Access Compliance Report

Public Rights-of-Way

(Curb Ramps)

Intersection ID: 29963	Main Street: CANIPE_DR	Cross Street: ROYAL_BLUFF_DR	Location: W
ADA ID: 549230BA5EFC	Ramp Type: PerpDiag	Initial Pass/Fail: Fail	Overall Compliance: No
Severity Score: 10			
Codes/Mitigation Info/Possible Solution		Field Measurements/Component Compliance

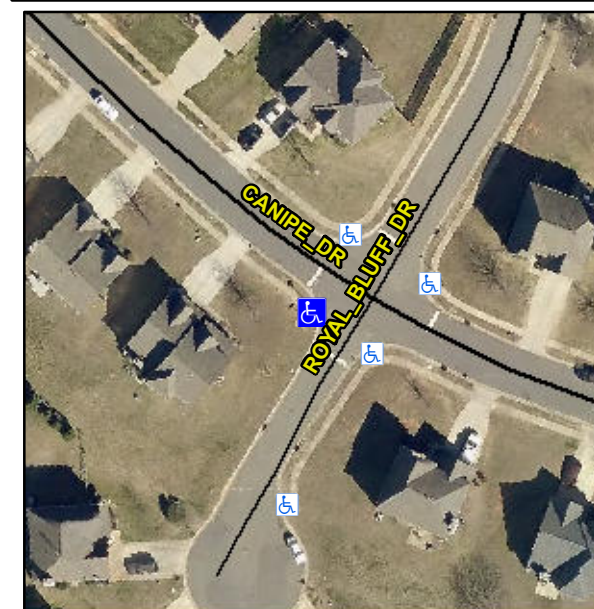
Not Found, R304.5.1, R304.5.3

Compliance	Description	Data	Compliance	Description	Data
N/A	Ramp Length (in)	48.0	Yes	Ramp Slope (%)	5.1
No	Ramp Width (in)	40.0	No	Ramp XSlope (%)	4.0
N/A	Flare Type LT	N/A	N/A	Flare Type RT	N/A
N/A	Flare Slope LT (%)	N/A	N/A	Flare Slope RT (%)	N/A
N/A	Flare Traversable LT?	N/A	N/A	Flare Traversable RT?	N/A
N/A	Landing Length (in)	N/A	N/A	DWS Provided?	N/A
N/A	Landing Width (in)	N/A	N/A	DWS Contrast?	N/A
N/A	Landing Slope (%)	N/A	N/A	DWS Length (in)	N/A
N/A	Landing X Slope (%)	N/A	N/A	DWS Full Width?	N/A
N/A	Landing Curb? (Y/N)	N/A	N/A	DWS Offset (in)	N/A
N/A	Shared Landing?	N/A			
N/A	Gutter Ponding?	N/A	N/A	Gutter Slope (%)	N/A
N/A	Gutter Lip Ht (in)	N/A	N/A	Gutter X Slope (%)	N/A
N/A	Painted X Walk1?	No	N/A	Painted X Walk2?	No
	X Walk 1 Direction	To SE		X Walk 2 Direction	To NE
N/A	X Walk 1 Width (in)	N/A	N/A	X Walk 2 Width (in)	N/A
	X Walk 1 Slope (%)	1.1		X Walk 2 Slope (%)	6.6
	X Walk 1 X Slope (%)	5.9		X Walk 2 X Slope (%)	0.3

Remove & Replace Curb Ramp With Two New Directional Ramps or Equivalent.
